Project	IEEE 802.16 Broadband Wireless Access Working Group < http://ieee802.org/16 >	
Title	Fixes for Lost of MOB_BSHO-REQ Messages	
Date Submitted	2008-03-10	
Source(s)	Chi-Chen Lee, I-Kang Fu MediaTek Inc. No. 1, Dusing Rd. 1 Science-Based Industrial Park, Hsinchu, Taiwan 300	chichen.lee@mediatek.com IK.Fu@mediatek.com
Re:	IEEE 802.16 Letter Ballot Recirculation #26b, on P802.16Rev2/D3, as announced in IEEE 802.16-08/006.	
Abstract	In IEEE 802.16 Rev2/D3, there is no definition on MS's/BS's behavior when the message MOB_BSHO-REQ message is lost. This contribution explains the potential problems and proposes a resolution to resolve this confusion.	
Purpose	Accept the proposed text modification to IEEE 802.16 Rev2	
Notice	<i>This document does not represent the agreed views of the IEEE 802.16 Working Group or any of its subgroups. It represents only the views of the participants listed in the "Source(s)" field above. It is offered as a basis for discussion. It is not binding on the contributor(s), who reserve(s) the right to add, amend or withdraw material contained herein.</i>

Fixes for Lost of MOB_BSHO-REQ Messages

Figure 1 – Lost of MOB_HO-IND (reject) message

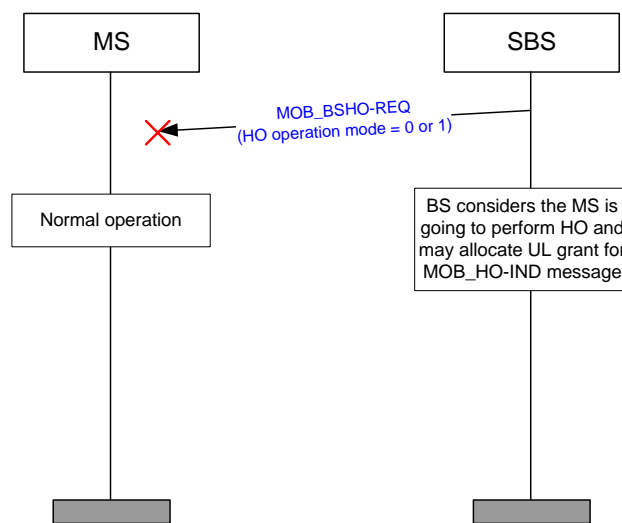
Current standard is not clear about what should BS behave if MOB_BSHO-REQ message is lost. The problematic scenario is described in Figure 1. If the MOB_BSHO-REQ message is lost, the MS is still in Normal operation but serving BS considers the MS is going to perform HO and expect MOB_HO-IND message from the MS. If the serving BS does not receive MOB_HO-IND message from the MS, it may consider the MS is performing HO and may stop DL and UL scheduling after certain time.

The suggested remedy is to define the mechanism to detect the lost MOB_BSHO-REQ message.

After BS transmits MOB_BSHO-REQ, BS shall not transmit any MOB_BSHO-REQ prior to expiration of timer BS handover retransmission timer. BS shall deactivate timer BS handover retransmission timer on reception of MOB_HO-IND message from MS. If the BS handover retransmission timer is expired and the BS

does not receive MOB_HO-IND message from MS, the BS may retransmit the MOB_BSHO-REQ message or react as if a MOB_HO-IND message has been received with HO_IND_type indicating serving BS release.
